UNITED STATES PATENT AND TRADEMARK OFFICE

10/664,666

Office Action Summary	Application No. 10/664,666	Applicant(s) HACKLER ET AL.	
	Examiner Eric W Thomas	Art Unit 2831

Fig. 4F

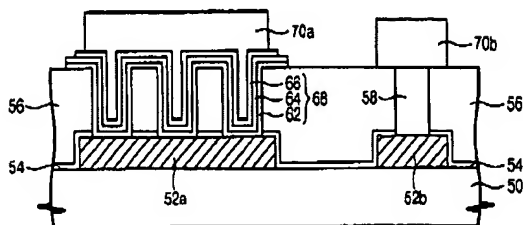
Jin et al. disclose in fig. 4f, a substrate (50), a conductive material (52a) formed above the substrate; an insulating material (54, 56) formed on the conductive material wherein the insulating material and the conductive material serve as a form for defining a plurality of capacitor trenches above the conductive layer, the insulating material defines the trench sidewalls and the conductive material defines the trench bases, a bottom electrode (62) formed onto the capacitor trenches so as to form a layer within the capacitor trenches in contact with the conductive material, wherein the bottom electrode extends up the sides of the capacitor trenches to form bottom electrode sidewalls; a capacitor dielectric (64) at least partially positioned on the bottom electrode; and a top electrode (66) at least partially positioned on the capacitor dielectric.

Regarding claim 11, Jin et al. disclose the bottom electrode further comprises a bottom electrode top wall (see fig. 4F).

Regarding claim 12, Jin et al. disclose the bottom electrode further comprises a bottom electrode base (see fig. 4F).

FIG.19

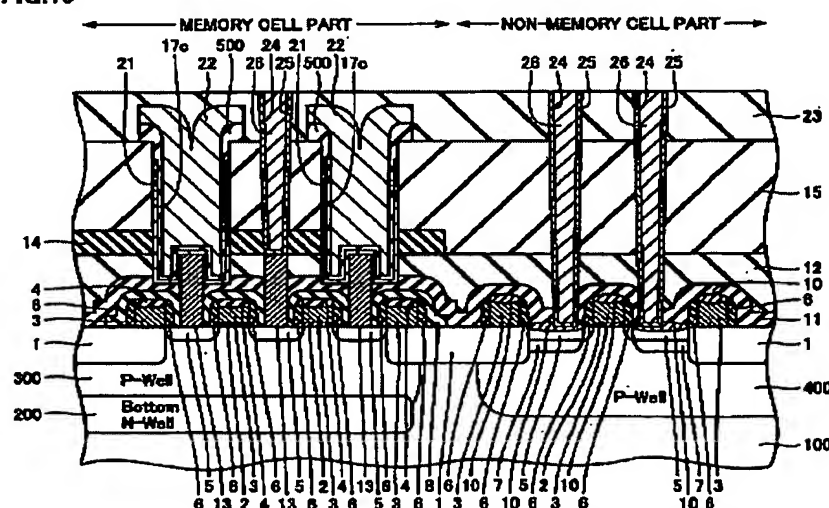
Kubo discloses in fig. 19, a capacitor structure comprising: a substrate (100), an insulating material (12, 14, 15) formed on the substrate, wherein the insulating material serves as a form for defining a capacitor trench; a bottom electrode (21), wherein the bottom electrode comprises a bottom electrode layer in the capacitor trench and a bottom electrode plug (13) disposed in the capacitor trench, wherein the bottom electrode layer extends up the sides of the capacitor trench to form bottom electrode sidewalls; a capacitor dielectric (500) at least partially position on the bottom electrode and at least partially formed on the bottom electrode plug; a top electrode (22) at least partially position on the capacitor dielectric and at least partially formed around the bottom electrode plug.

Regarding claim 35, Kubo discloses the bottom electrode and the capacitor dielectric are formed in the shape of a box (abstract and fig. 19).

Regarding claim 36, Kubo discloses the top electrode is ^{at} least partially disposed in the capacitor trench such that the top electrode interdigitates the bottom electrode (see fig 19).

Regarding claim 37, Kubo discloses the bottom electrode further comprises a bottom electrode top wall (see fig. 19).

Regarding claim 38, Kubo discloses the bottom electrode further comprises a bottom electrode base (see fig. 19).
